UNITED STATES PATENT AND TRADEMARK OFFICE

10/563,176

Office Action Summary	Application No. 10/563,176	Applicant(s) ROYO, PAUL	
	Examiner KINAM PARK	Art Unit 2828

DETAILED ACTION

FIG. 2

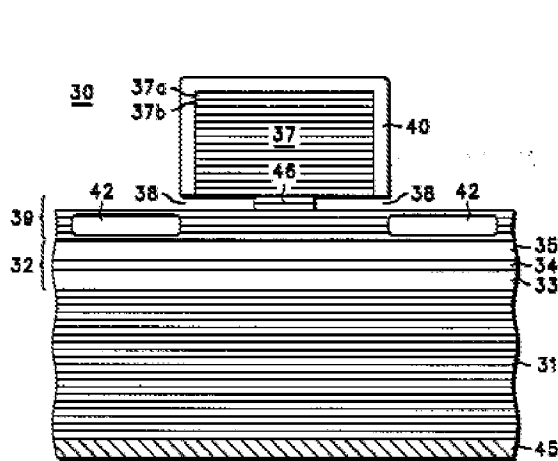
However, it is the examiner's interpretation that Shieh et al. disclose in figure 2 and 3 that an aperture layer (42) located above said first plurality of doped layers (31)

and formed of an insulating material that is substantially non-transparent for a specified wavelength range, the aperture layer having an aperture formed of conductive and optically transparent material with a first characteristic lateral size (d_{ox}) (see, figure 3 in the office action) is positioned and do have a size as configured as the applicant's aperture; thereby claim 1 can be anticipated by Shieh, et al.

SHIEH et al. discloses in figure 2, 3 and specification:

an aperture layer (42) located above said first plurality of doped layers (31) and formed of an insulating material that is substantially non-transparent for a specified wavelength range, the aperture layer having an aperture formed of conductive and optically transparent material with a first characteristic lateral size (d_{ox}), and

a second plurality of doped layers (37) having alternately a low Index of refraction and a high Index of refraction (see, col. 3, lines 55-57), the second plurality having a second characteristic lateral size (d_m), a difference of the first characteristic lateral size (d_{ox}) (see, figure 2 and 3), and

the second characteristic lateral size (d_m) being smaller than (d_{ox}) (see, figure 2 and 3) and being adapted to generate increased optical losses of said resonator with respect to higher order modes for said specified wavelength range compared to the optical losses caused by said aperture layer alone, and

Note that SHIEH et al. discloses in figure 2, 3 and specification a third characteristic lateral size (see, 44, Mesa, and 42) (**claim 2**), a metal layer (43) (**claim 3**), a second reflector (31) comprising a plurality of doped layers having alternatively a low index of
